TRANS/WP.29/GRE/2002/40
18 July 2002

World Forum for Harmonization of Vehicle Regulations (WP.29)

PROPOSAL FOR DRAFT AMENDMENTS TO REGULATION No. 99

(Gas-discharge light sources)

Figure 1 - Category D1R - Type with cables - Cap PK32d-3

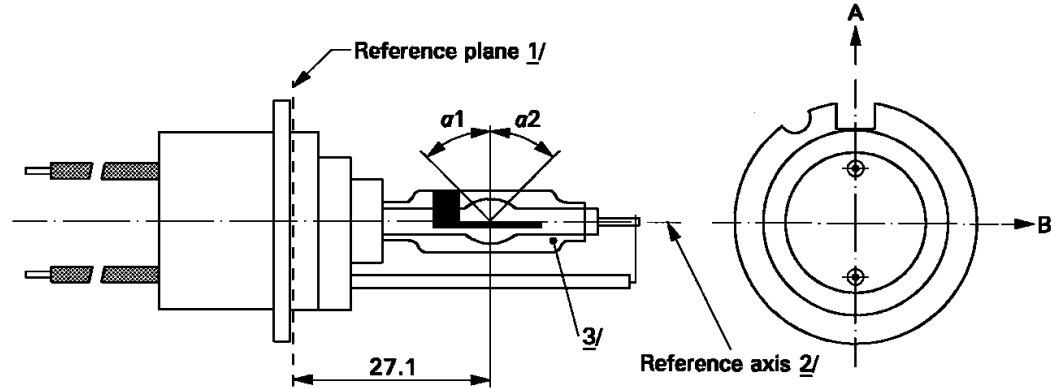
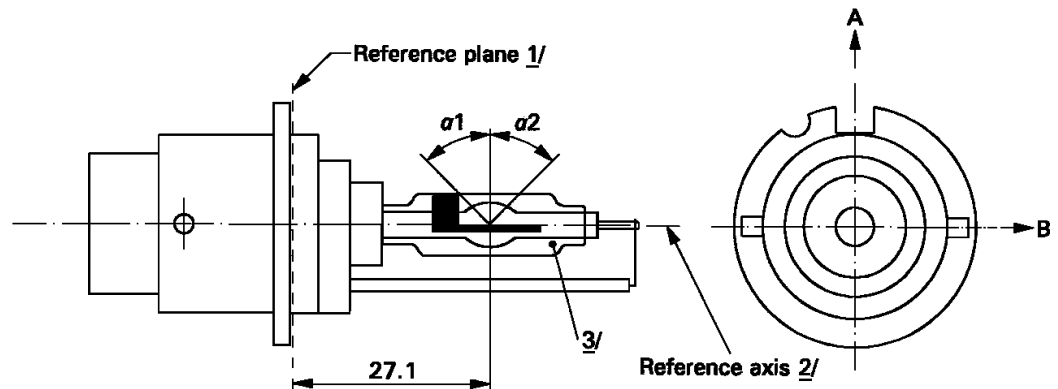
The proposed draft amendments also concern an update of references to IEC cap sheets because of the introduction of a maximum outline of the cap PK32d when equipped with a starting device (categories of light sources D1S and D1R).

- 1/ The reference plane is defined by the positions on the surface of the holder on which the three supporting bosses of the cap ring will rest.
- 2/ See sheet DxR/3.
- 3/ With respect to the reference axis, when measured at a distance of 27.1 mm from the reference plane the eccentricity of the outer bulb shall be less than ± 0.5 mm in direction B and less than $+ 1$ mm $/- 0.5$ mm in direction A.

Figure 3 - Category D3R - Type with starter - Cap PK32d-6

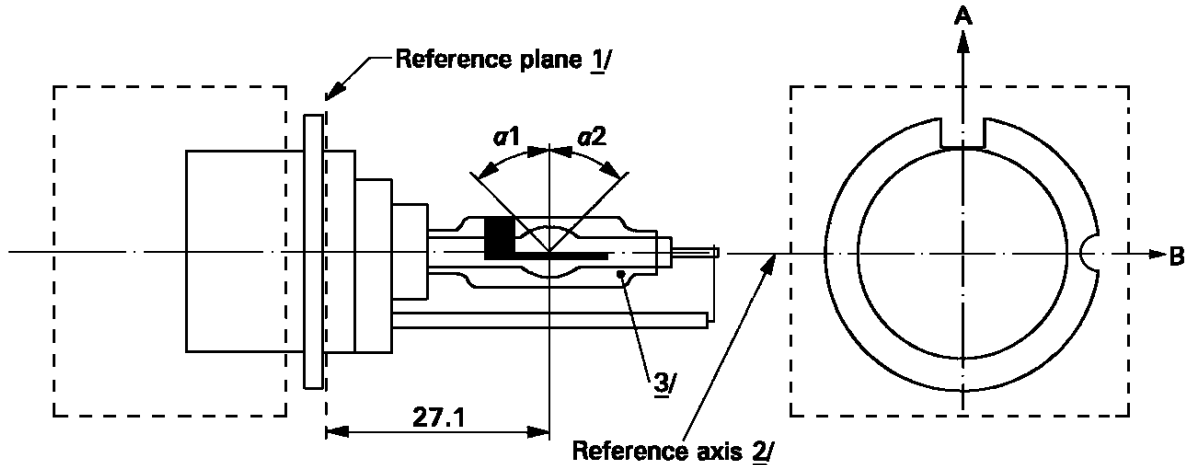
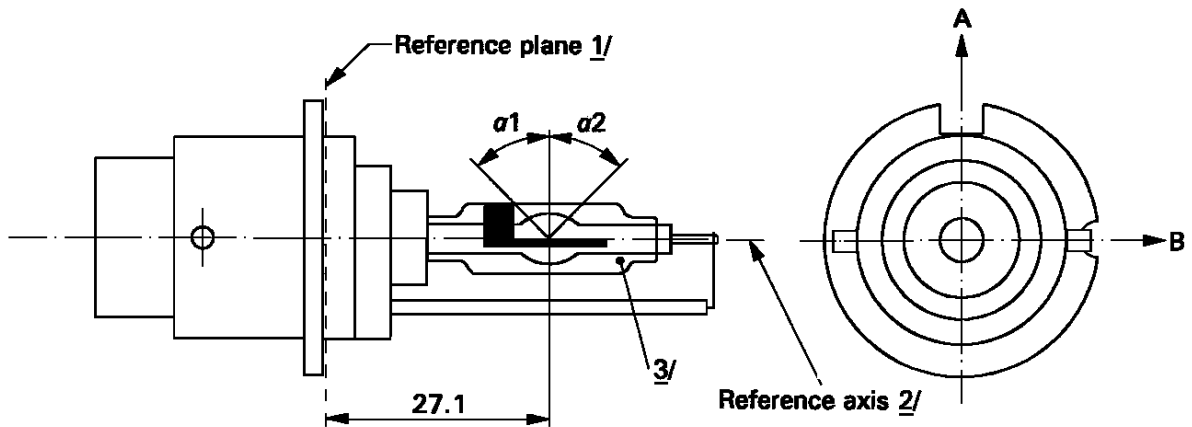
Note: The text reproduced below was prepared by the expert from GTB in order to introduce in the Regulation (mercury-free) gas-discharge light sources of the categories: D3R, D3S, D4R, D4S. The draft proposal is based upon the text of Revision 1. The inserted text is in **bold** characters.

The proposed draft amendments concern the addition of new categories of gas-discharge light sources.

- 1/ The reference plane is defined by the positions on the surface of the holder on which the three supporting bosses of the cap ring will rest.
- 2/ See sheet DxR/3.
- 3/ With respect to the reference axis, when measured at a distance of 27.1 mm from the reference plane the eccentricity of the outer bulb shall be less than ± 0.5 mm in direction B and less than $+ 1$ mm $- 0.5$ mm in direction A.
